PLAN SHOWING
PROPOSED BUILDING
ON PLOT NO. 13 BLOCK E.1.
PREEDY QUARTER
SCALE = 8" = 1."

In reply to your letter No. B.S.P 103/37 dated 5th instant in connection with plot No. 13- E I Freedy Quarter we beg to return the plan duly amended as under:-

Reference No. B. S. P. 103/37.

REVIEW FORM

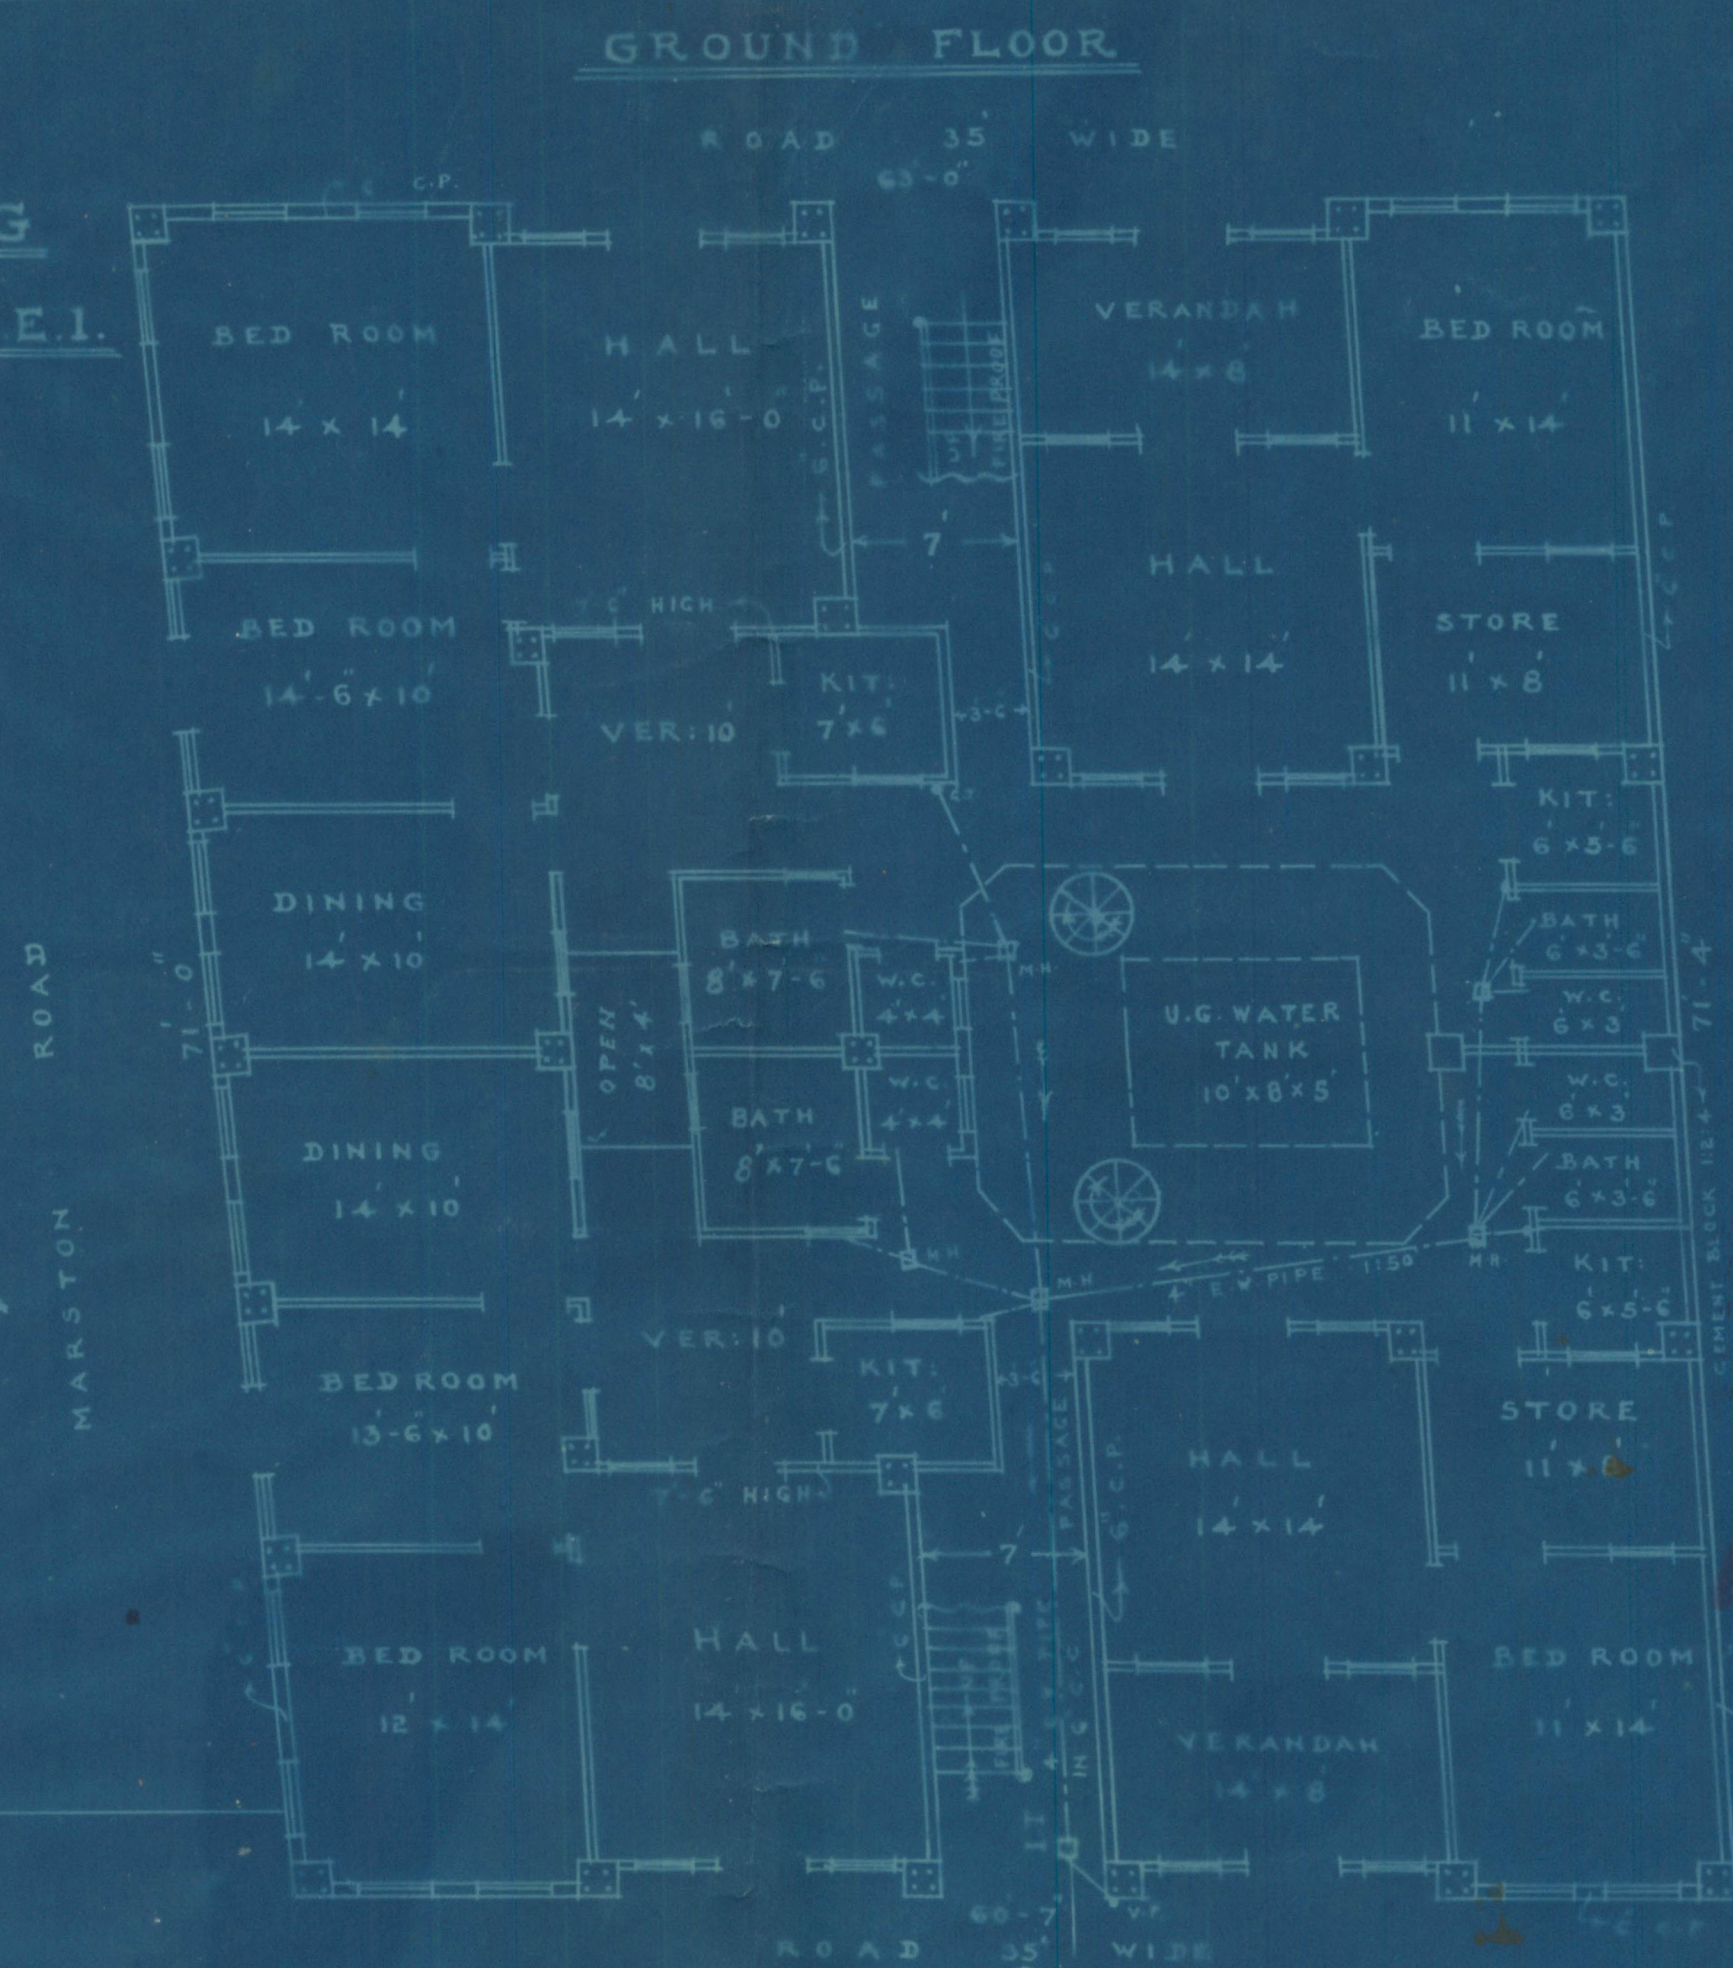
1. Rooms marked with ? are dark and ill ventilated.
2. sizes of R.C.C. pillars be put down.
3. Calculation for load coming on the foundation be submitted.
- ✓ 4. For 10' span the thickness of slab should be 5" and for
11' span 5½".
- ✓ 5. The height should be limited to 55' for 16' internal
open space.
- ✓ 6. What about light to the verandah. X X.
7. Window be provided at W.

1. Sizes of R.C.C Pillars be put down.
2. Load calc. calculation, for load coming on the foundation be submitted.
3. For 10' span the thickness of slab should be 5" and for 11' span $5\frac{1}{2}$ ".
4. The height should be limited to 55' for 16' internal open space.
5. What about light to the verandah + +.
6. window be provided as w.

- 1,6&7. The plan as now amended is agreed by the H.O as through ventilation has been provided.
2. Table showing sizes of the R.C.C. pillars has been shown on the plan.
3. Calculations are attached herewith.
4. Thickness of slab has been changed.
5. The height of the building has been limited to 55 ft.

Load calculation over ~~xxxxxx~~ R.C.pillar "A" 1.75x 1.75 - 3.06sft

Safe load carried by R.C.pillar 3.06 x 47 - 144 tons

1. Total weight of pillar A from ground to 4th floor - 1x 1.5x 1.5x 55x 150-18562.50 lbs		
2. 3" C.P all the floors	- 2x 7x 40x 35	-19600.00 "
3. 3" c.p....do.....	- 3x 6x 40x 35	-25200.00 "
4. R.C.C.roofs.....	- 5x16x14x140	-156800.00 "
5. R.C.C.beams.....	5 x { 2x7x1.33x.67x150 3x6x 1.0 x.5x150	- 16102.50 "
		----- 236265.00 "
		- 105. 5 tons

ie 35 tons per 1sft which is quite safe

Calculation of safe load over foundation

1x 5.5x 5.5 sq ft

1. Weight of pillars, floors, c.p etc as above -	236265. 0lbs
2. Do plinth & R.C.founds 1x 2.67x 2.67x 5x150-	6172. 5 "

242337. 5

ie 108. 0 tons

ie 3.56 tons per 1sft which is quite safe.

Load over Moram Soil 5.5 x 5.5 - 30.25 sft

1. Weight of pillars, floors etc etc.....	242337. 5
2. Weight of concrete. 1x 5.5x 2 x 150-	9075.0
----- 251412. 5 lbs

ie 112. 2 tons

ie 3. 7 Tons per 1sft of Moram ~~foundation~~ Soil.

which is quite safe as per P.W.D Hand Book ^{Vol. 1} No 19 of Tables
Page 123 Volume 1.
